## ADDENDUM

NO. 3

**PROJECT NAME:** Johnson High School 2025 Additions and Renovations

**ADDENDUM DATE:** 15 May, 2025

## 1 ROOF FRAMING PLAN - AREA B

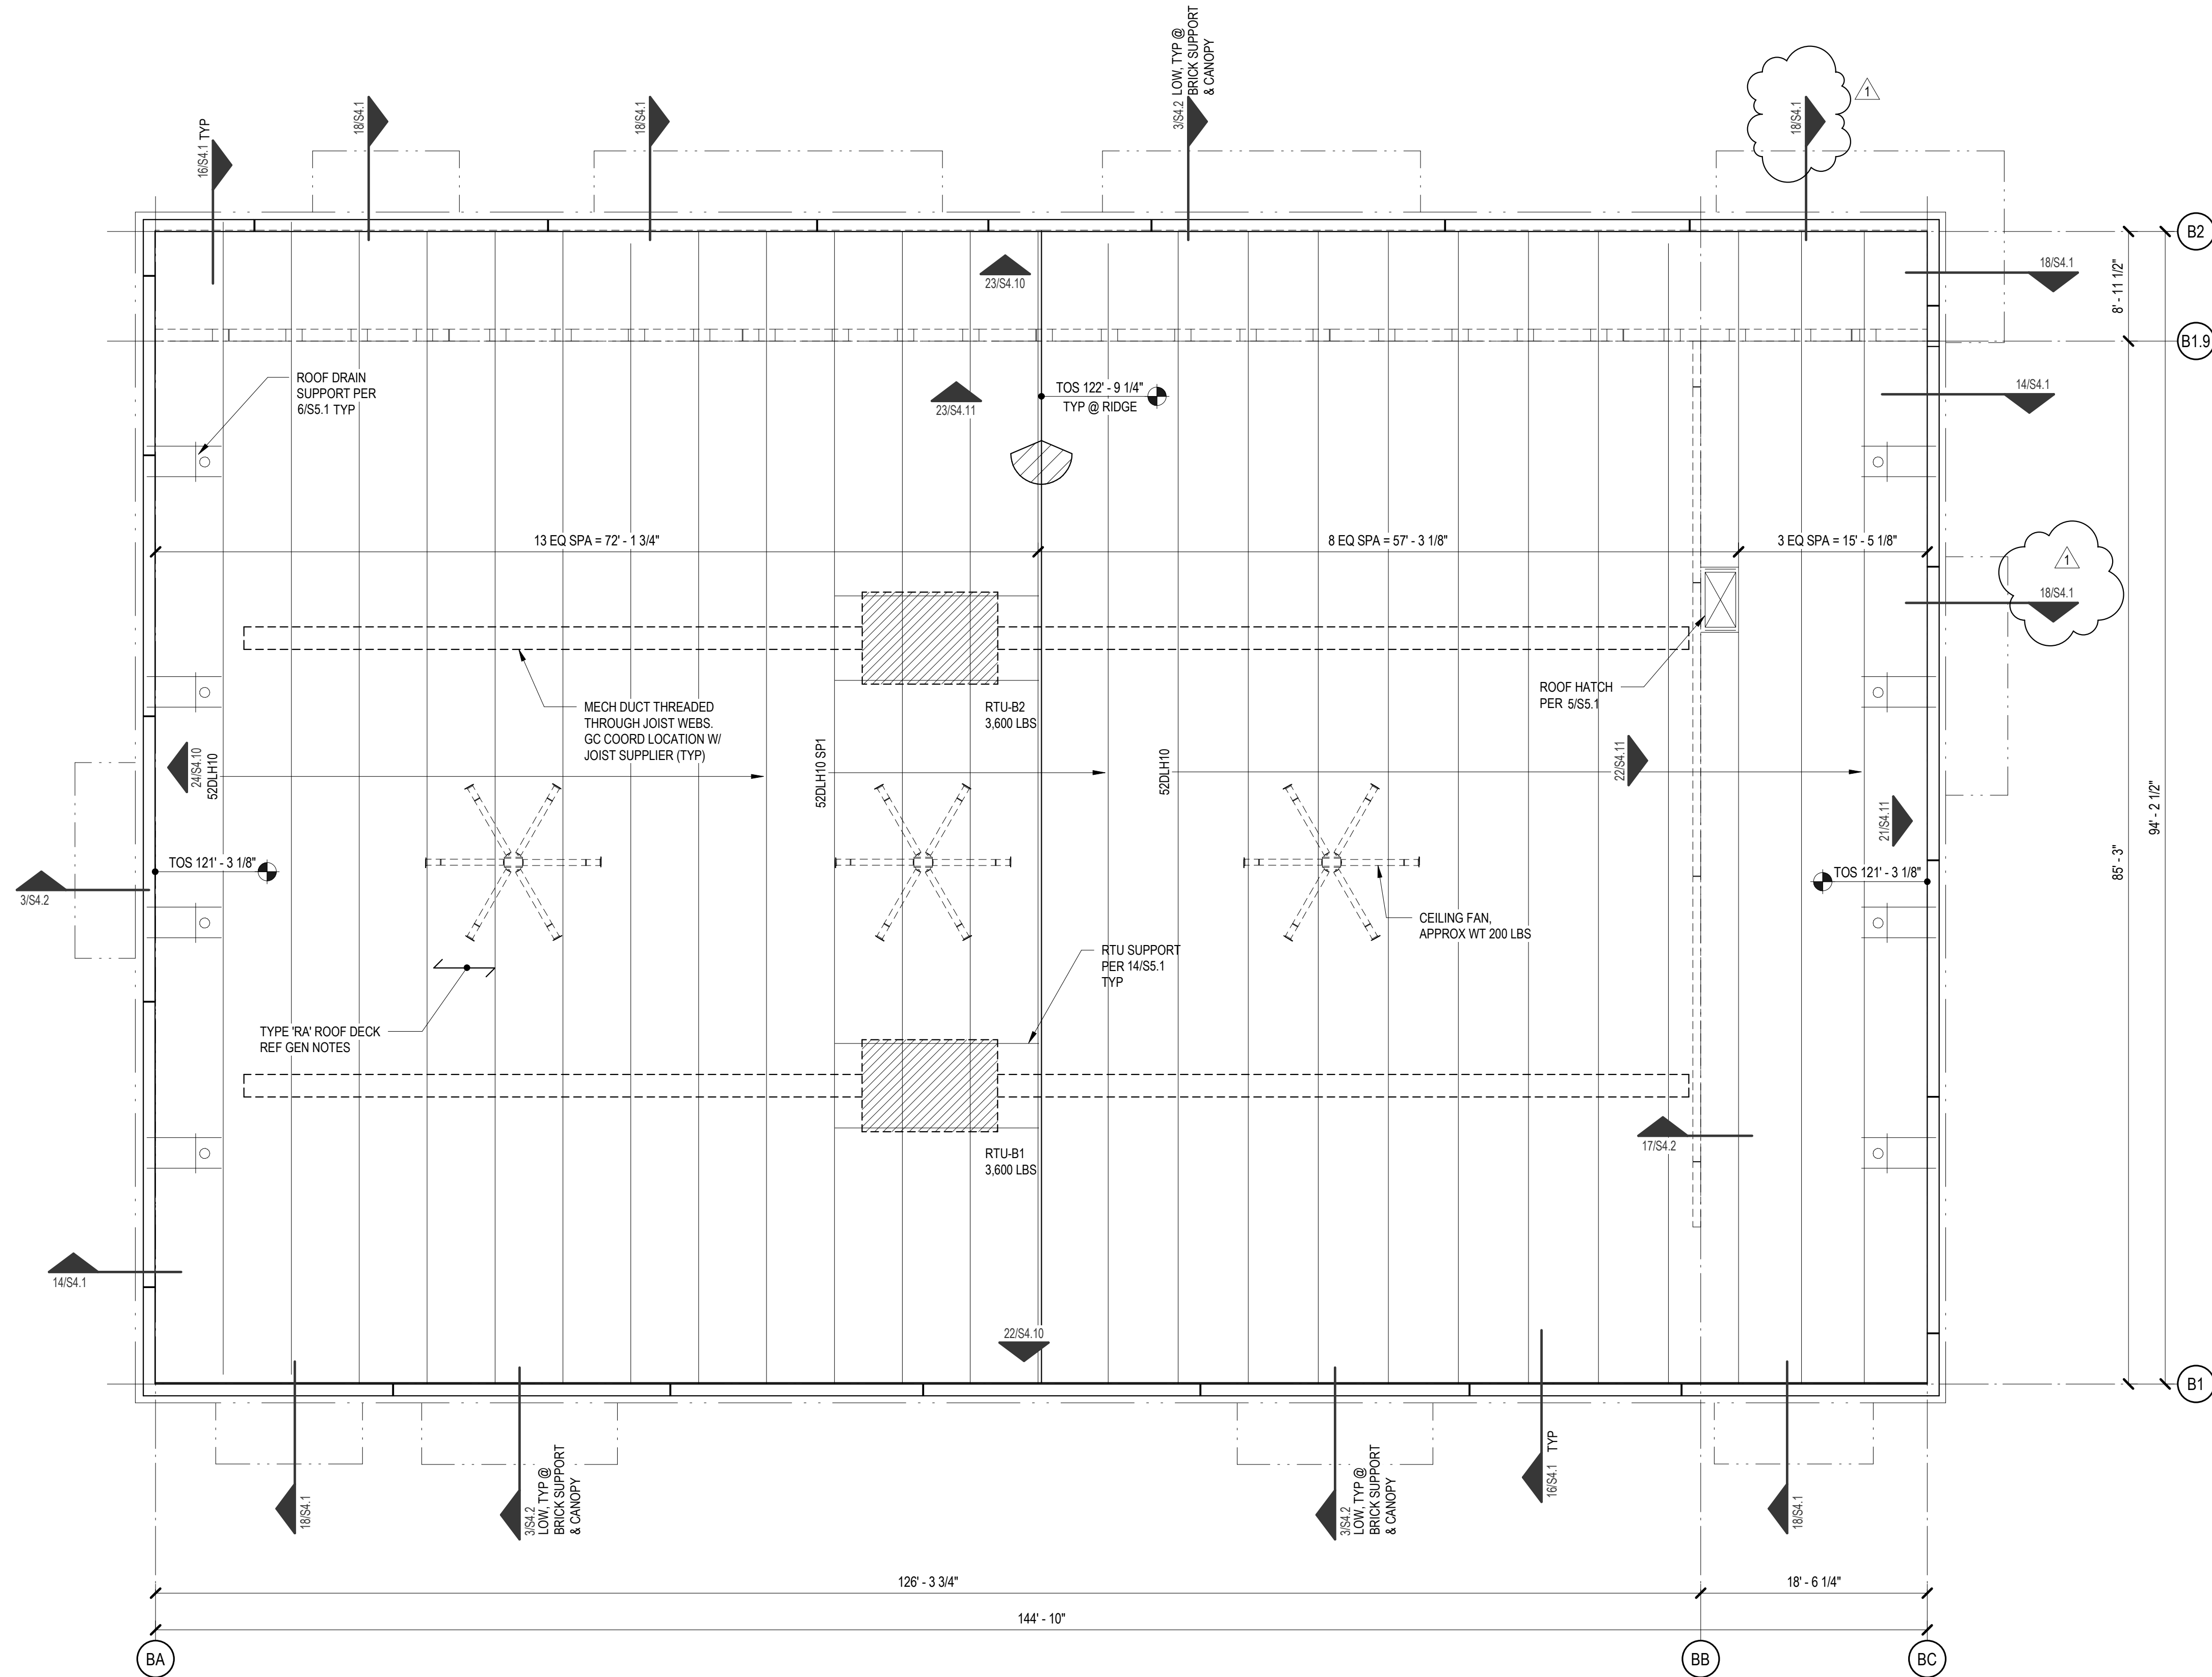
**AD No 3, Struct Item 5: To the Drawings, Sheet S2.1B2 "ROOF FRAMING PLAN – AREA B"**

- 1) Revised section callouts at canopies.

22 TYPICAL PLUMBING VAULT  
3/4\"/>

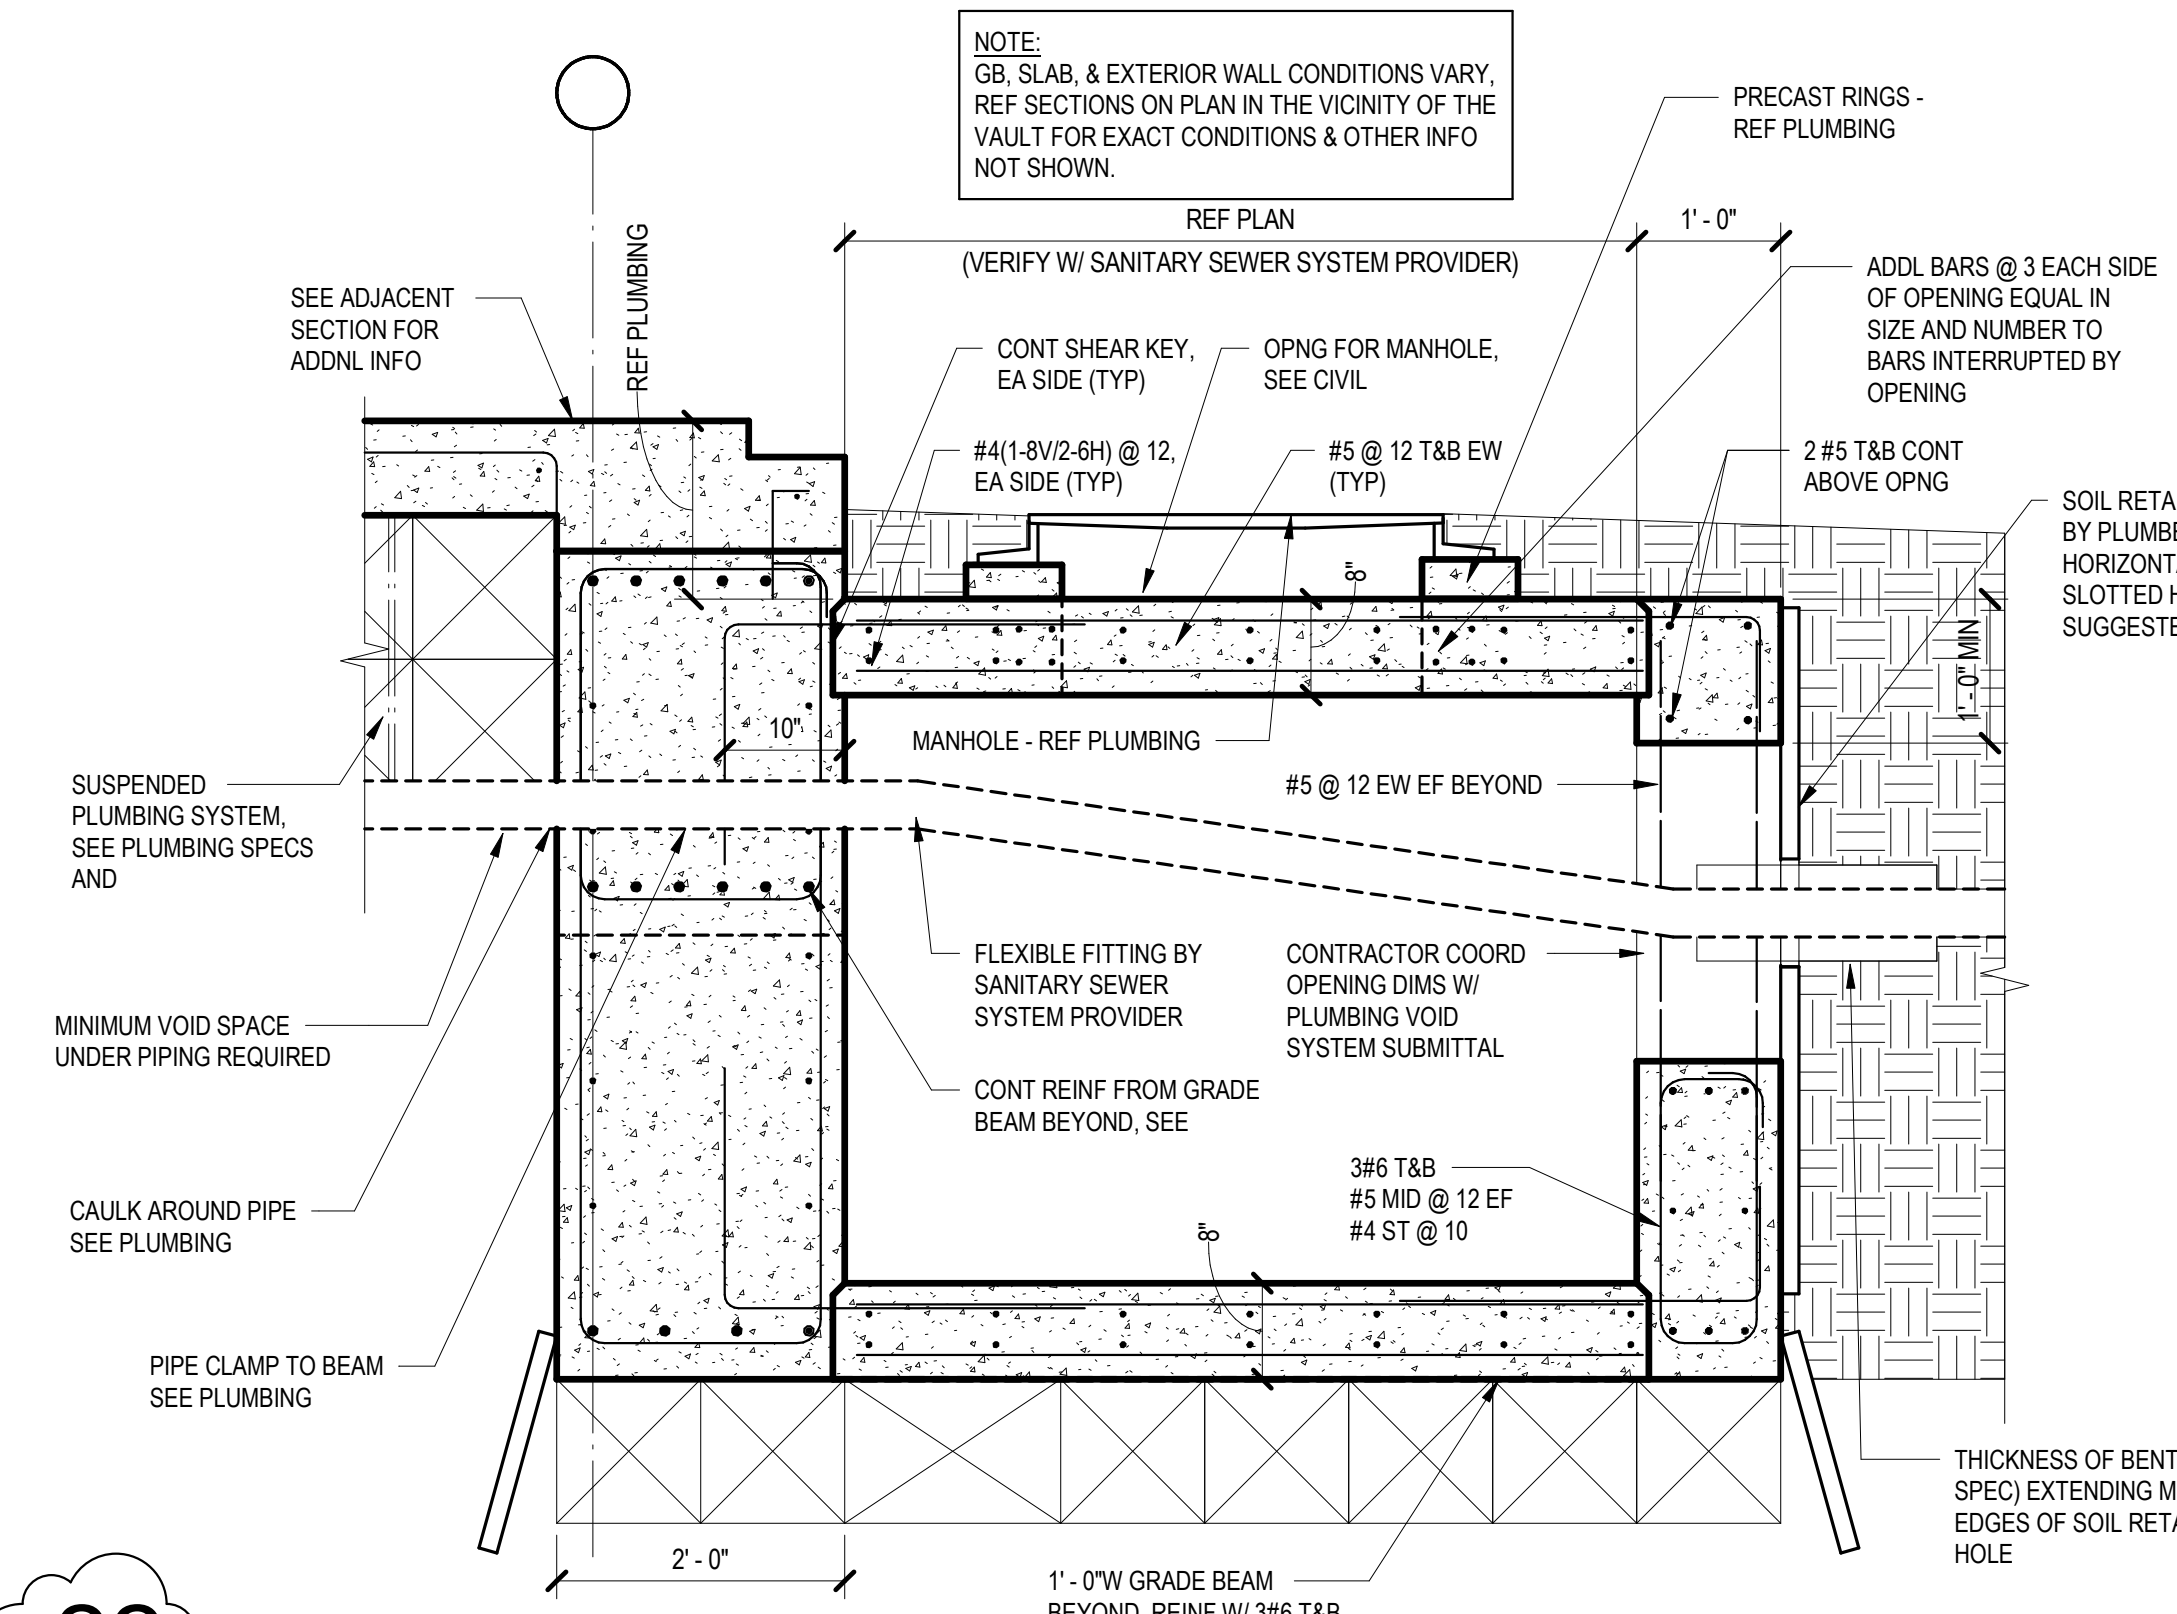
**AD No 3, Struct Item 6: To the Drawings, Sheet S3.2 "CONCRETE DETAILS"**

- 1) Revised plumbing vault detail.
